Re: Florida Power & Light Company
Proposed Turkey Point Units 6 and 7
Docket Nos. 52-040 and 52-041
Response and Response Schedule to NRC Request for Additional Information
Letter No. 043 (eRAI 5875) SRP Section - 02.05.03 Surface Faulting

SRP Section: 02.05.03 – Surface Faulting

NRC RAI Number: 02.05.03-1 (eRAI 5875)

Figure 1: Areas evaluated for size and density of vegetated patches

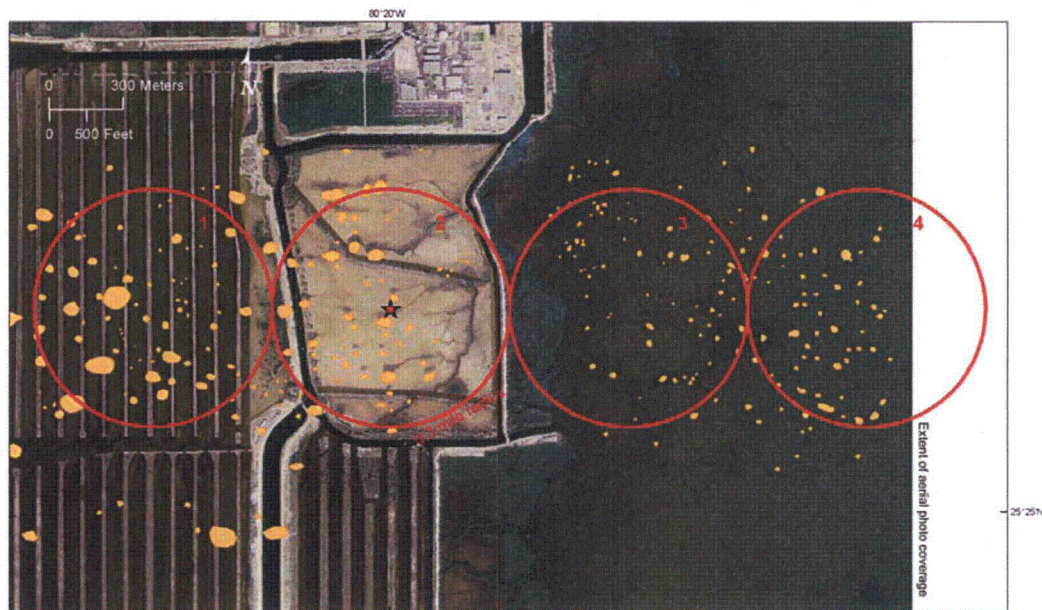
- a) Discuss how you evaluated the apparent semi-circular alignments of individual off-shore depressions. Discuss if the features may be consistent with incipient collapse into a larger underlying void, such as the cenotes of the Yucatan or the filled sink in nearby Key Largo Marine Sanctuary reported by Shinn et al., 1996, Ref 228.
- b) Discuss a possible timeframe when such features could have formed and whether they could have formed at similar elevations below Units 6 and 7.

Further analysis of the submarine vegetated patches was conducted. Four circular areas with radii of 0.3 mi were evaluated for density of surficial depressions or vegetated patches. Two onshore circles were drawn, one centered on the site (circle 2) and one just west of the site (circle 1). Similarly, two offshore circles were drawn, both east of the site (Figure 1). Subaerial depressions were interpreted from 1940 aerial photography (1:40,000 scale), and submarine vegetated patches were interpreted from 1986 aerial photography (1:40,000 scale) (Figure 2.5.3-202 and Figure 1). Detailed mapping was performed to a scale of about 1:2,000 to define the locations and extents of patches within, and immediately surrounding each circular area. Data from the two subaerial circular areas (circles 1 and 2 in Figure 1) and the two submarine circular areas (circles 3 and 4 in Figure 1) are shown in Table 1.

The average areas of the individual vegetated patches in the subaerial circles 1 and 2 are 780 m² and 540 m² and the average areas for the submarine circles are 320 m² and 180 m² (Table 1). While the submarine patches have a lower average area, the values for both locations (subaerial and submarine) are of the same order of magnitude. The size distribution of the patches in both the subaerial and submarine environments is variable, with high standard deviations for the average patch area, and a size range that varies from 20-30 m² to >100 m². Very similar vegetated patch densities are calculated for subaerial and submarine areas (Table 1). The statistics for the subaerial circles are somewhat skewed by the presence of a few very large patches (especially in circle 1), reflected by the fact that the standard deviations in these circles are actually larger than the mean. These outliers may in fact consist of several smaller patches, which have been obscured by vegetation. Otherwise, the patches in all four circles display very similar characteristics, with similar minimum patch sizes and population densities. The similarity of the vegetated patch size and distribution in all four circles suggests that they could have been formed by the same process, namely surficial erosion and/or solution (see FSAR p. 2.5.3-3 and RAI 02.05.02-1 response (FPL Letter L-2011-234, dated June 24, 2011)).
